ADDENDUM NO. 7

PROJECT NO. DGS C-1576-0010 PHASE 001
PROJECT TITLE - SCI Frackville - Electrical Upgrades
PROFESSIONAL:

PROJECT NO. DGS C-1576-0010 PHASE 1
PROJECT TITLE – SCI Frackville – Electrical Upgrades
LOCATION – Frackville, PA
Greenman Pedersen Inc, Scranton, PA 18505

THIS PAGE INTENTIONALLY LEFT BLANK

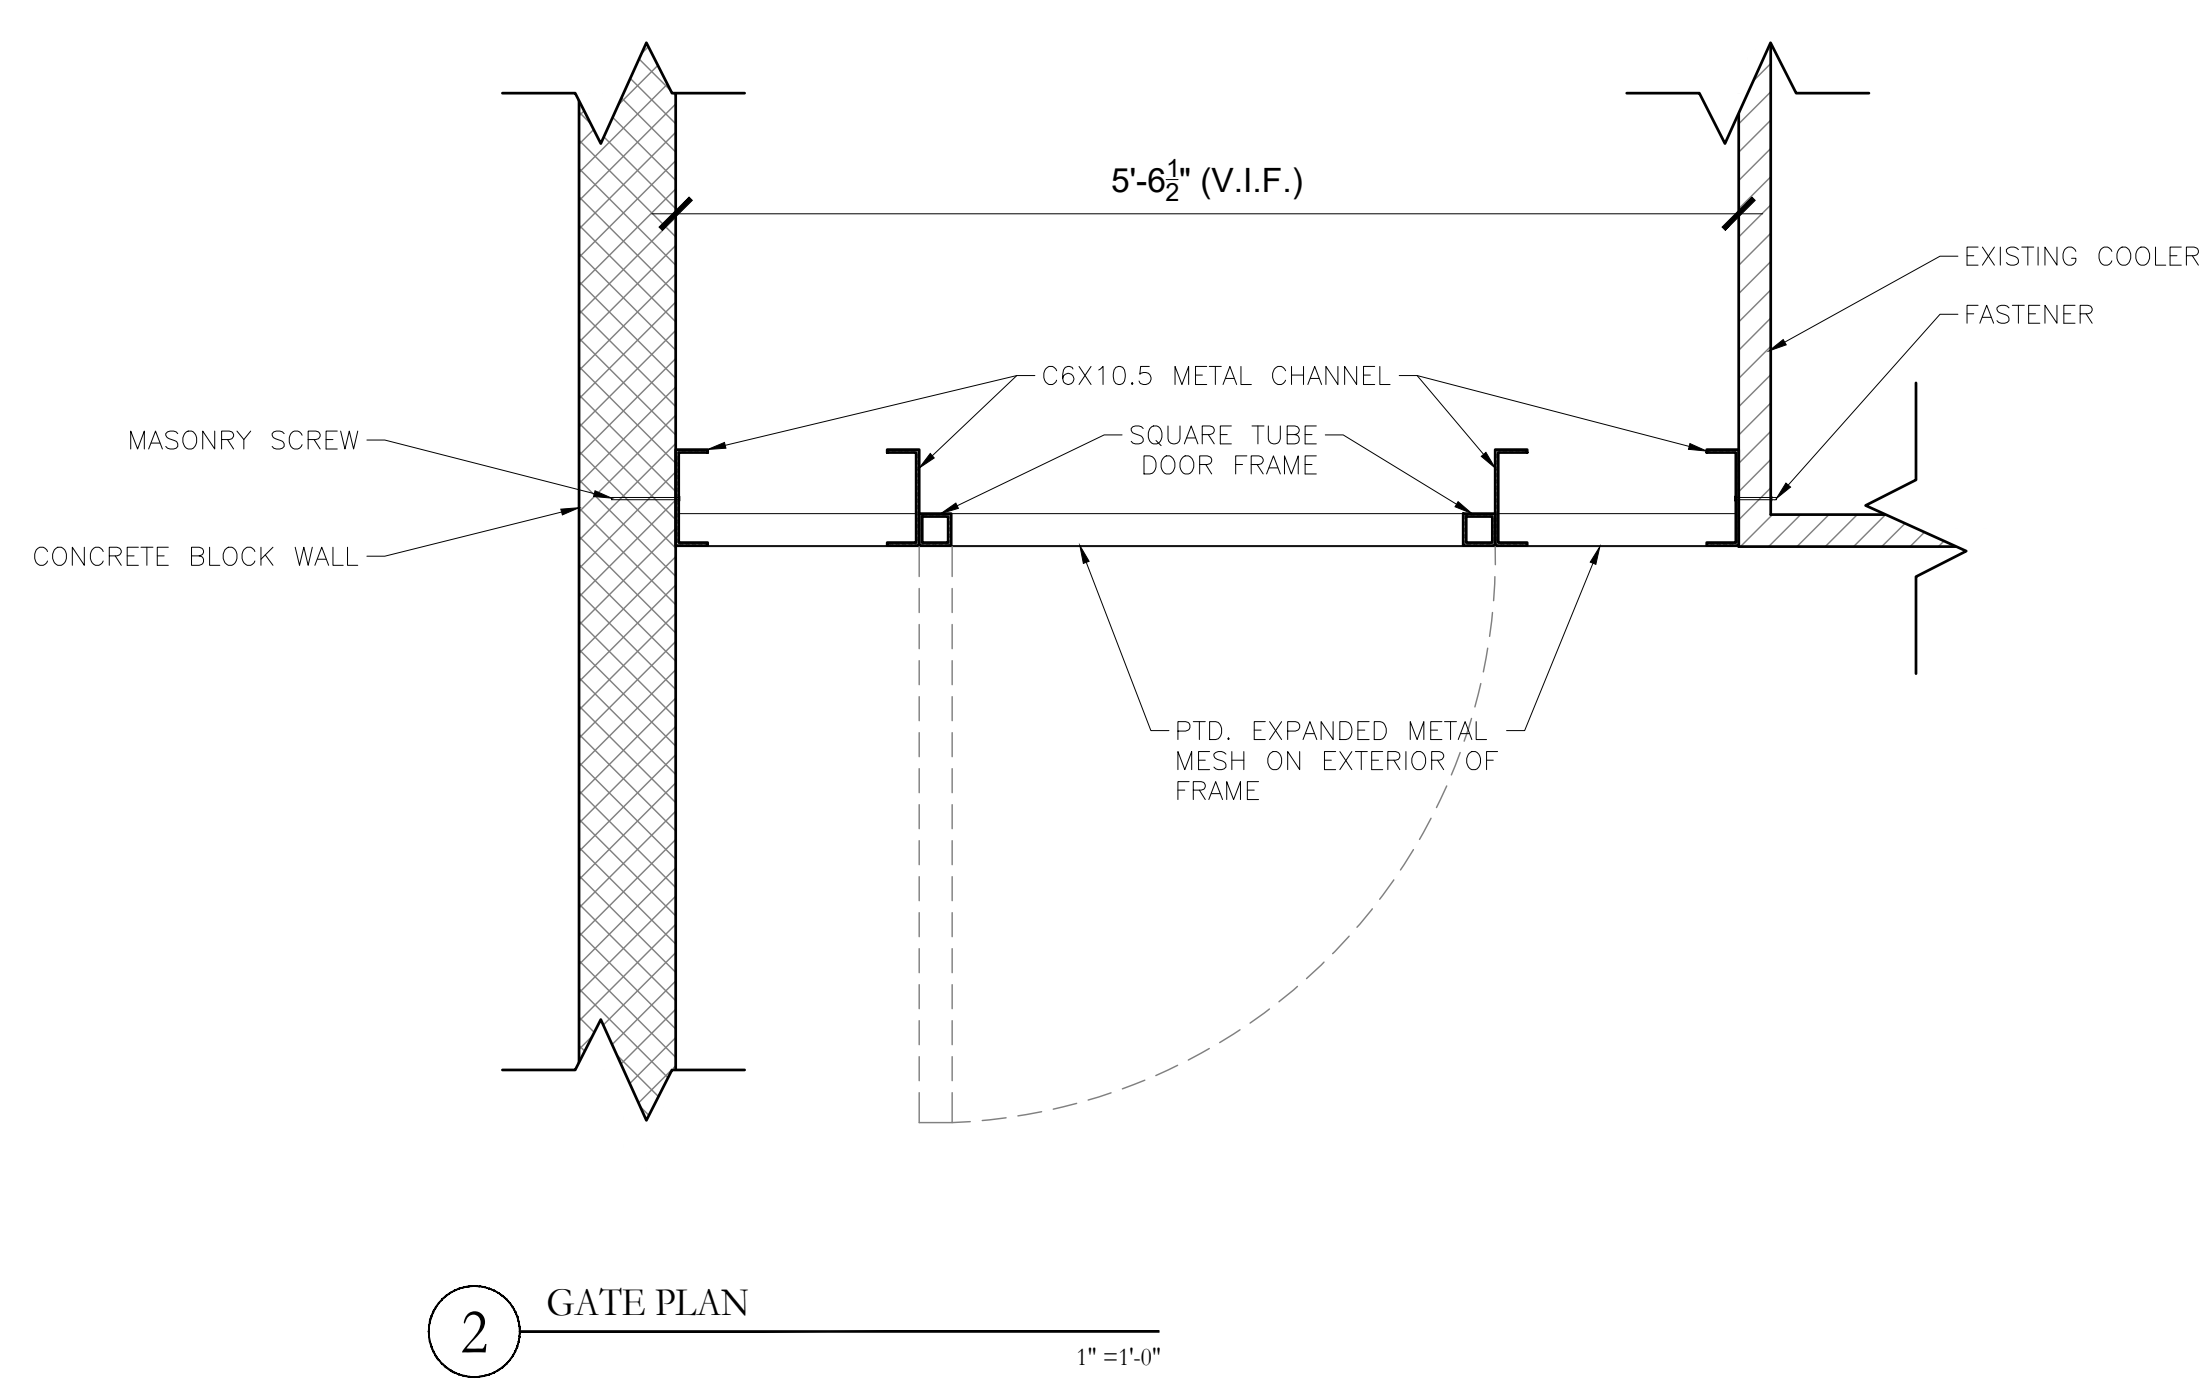
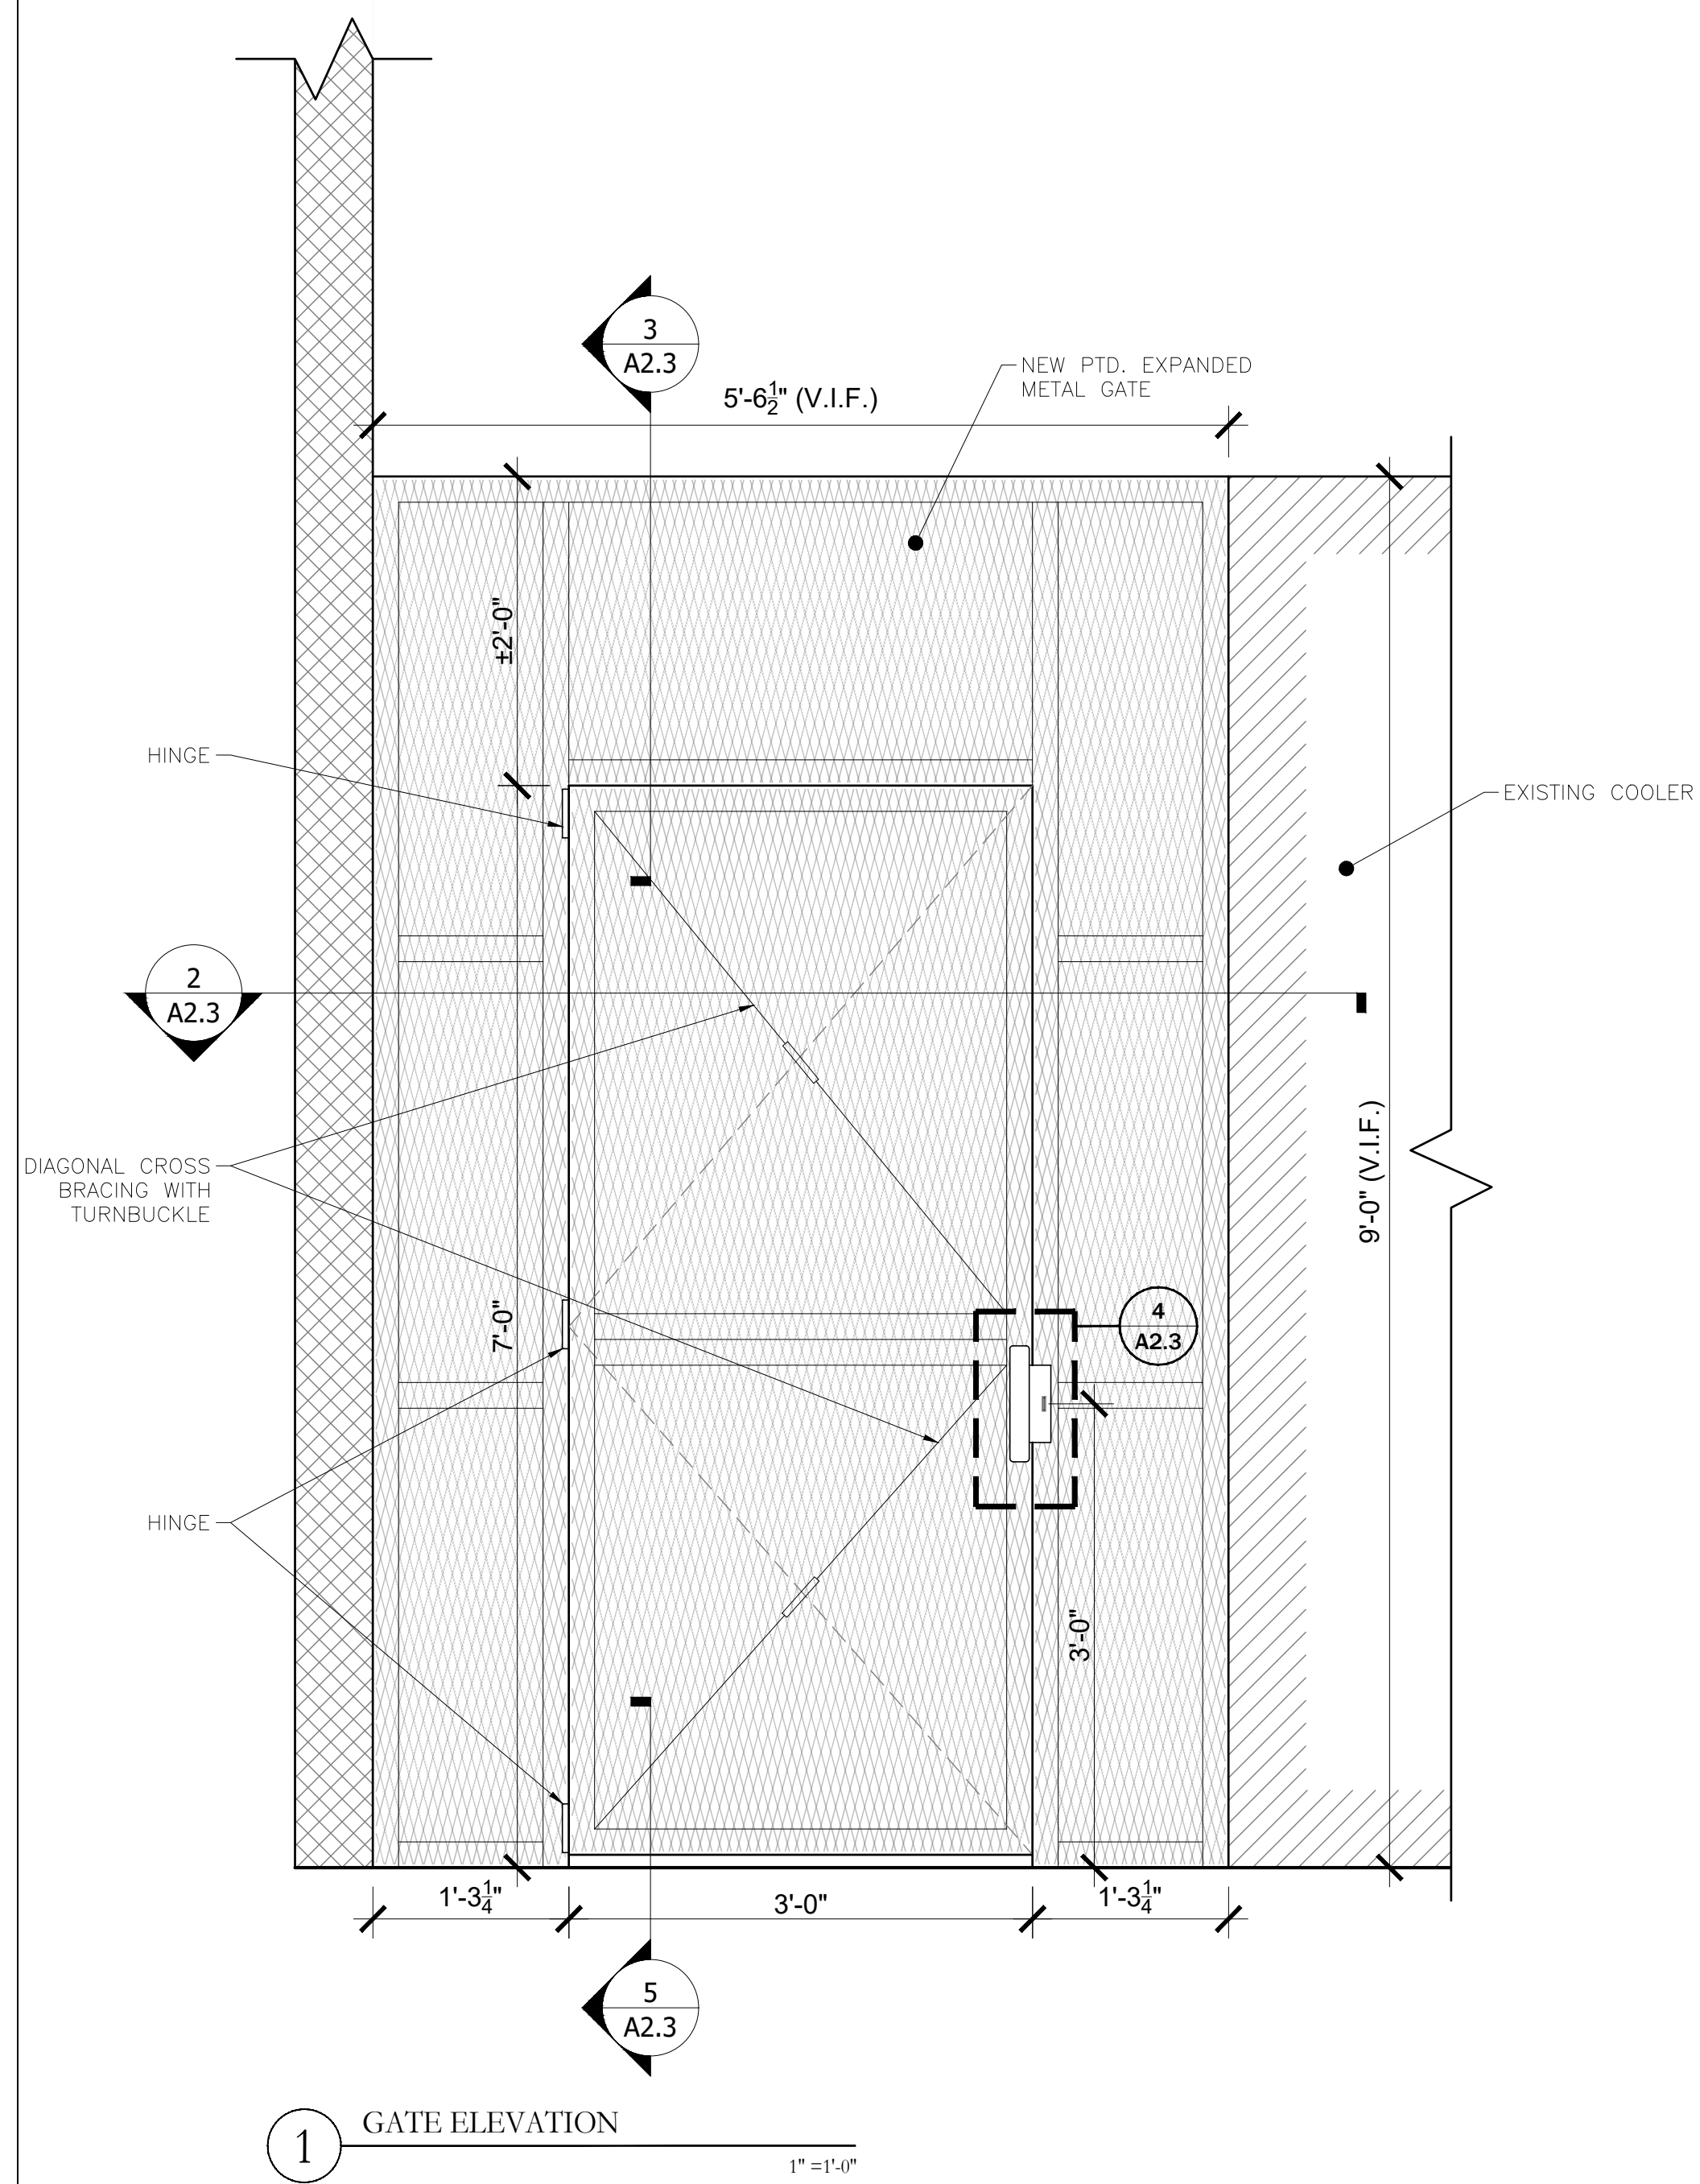
Item 2- Sheet A2.3: Added ceiling detail to sheet. See attached drawing.
